RENFREW HYDRO INC.

2017 Cost of Service Application Response to Interrogatories

EB-2016-0166

**Response to Interrogatories
2017 Cost of Service Rate Application
Renfrew Hydro Inc. (Renfrew Hydro)
EB-2016-0166
November 21, 2016**

Renfrew Hydro provides pie charts of Capital Expenditures in Figure 38.

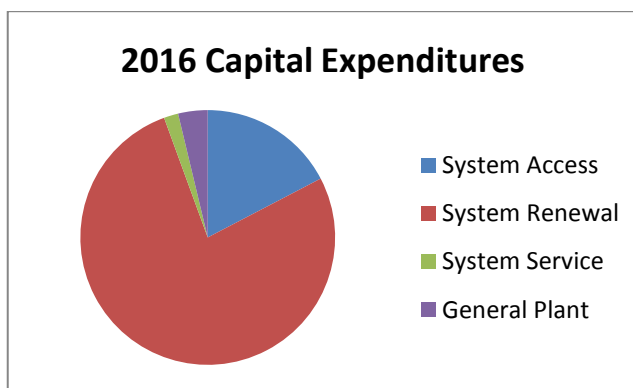
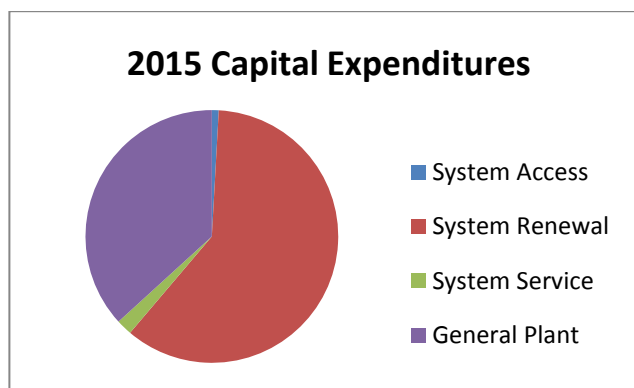
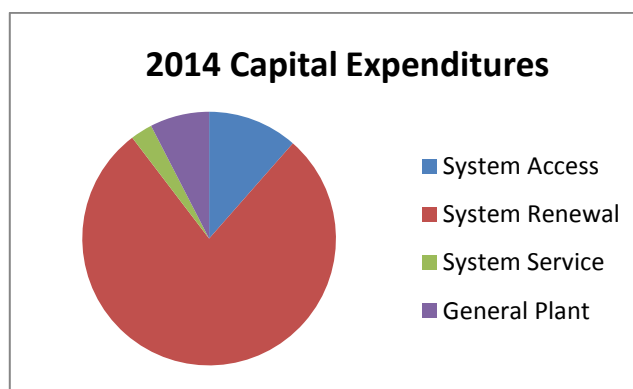
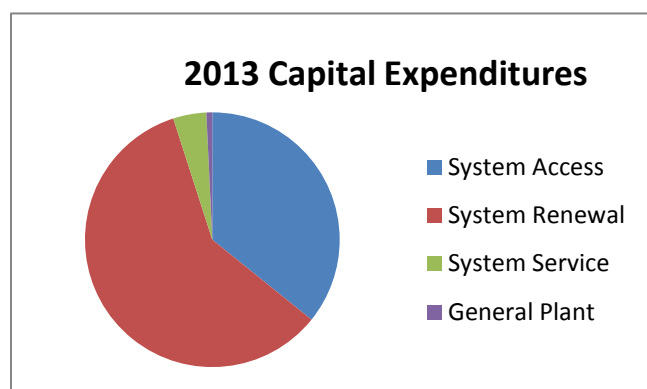
Please explain why the pie chart for 2013 and 2014 does not match the values provided in Figure 32.

The pie charts for 2013 and 2014 in Figure 38 contained errors. The charts have been reproduced below to match the values provided in Figure 32.
